Addendum to Planning Justification Statement

Erection of Container Storage at Storage Room to the Rear of Eastwoods Service Station, Ashby Road, Stapleton, LE9 8JE

Prepared by Landmark Planning Ltd

August 2023

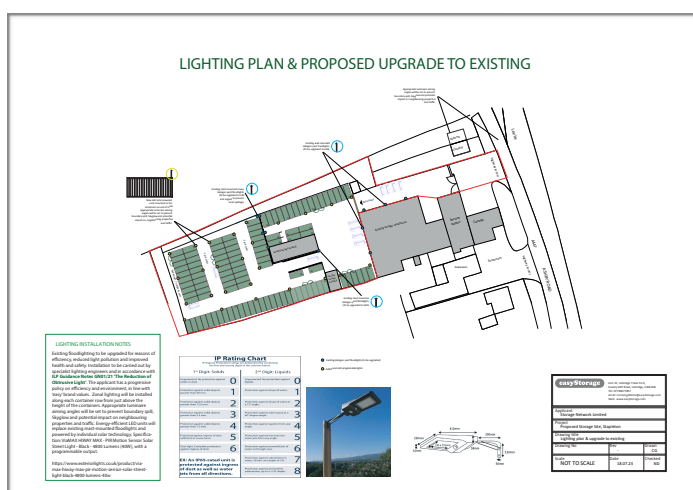
- '1. Please can the applicant provide the proposed operating hours of the site.
2. Please can the applicant provide details of the proposed lighting of the site - the site lighting should be compliant with the Institution of Lighting Professionals guidance document "The Reduction of Obtrusive Light".'

Existing floodlighting to the site shall be upgraded for reasons of efficiency, reduced light pollution and improved health and safety. Installation shall be carried out by specialist lighting engineers and in accordance with ILP Guidance Notes GN01/21 'The Reduction of Obtrusive Light'. The applicant has a progressive policy on efficiency and environment, in line with 'easy' brand values. Zonal lighting will be installed along each container row from just above the height of the containers. Appropriate luminaire aiming angles will be set to prevent boundary spill, Skyglow and potential impact on neighbouring properties and traffic. Energy-efficient LED units will replace existing masted floodlights and powered by individual solar technology. Specification: ViaMAX HIWAY MAX - PIR Motion Sensor Solar Street Light - Black - 4800 Lumens (40W) - see link for product <https://www.exteriorlights.co.uk/product/viamax-hiway-max-pir-motion-sensor-solar-street-light-black-4800-lumens-40w>

A lighting plan has also been provided:
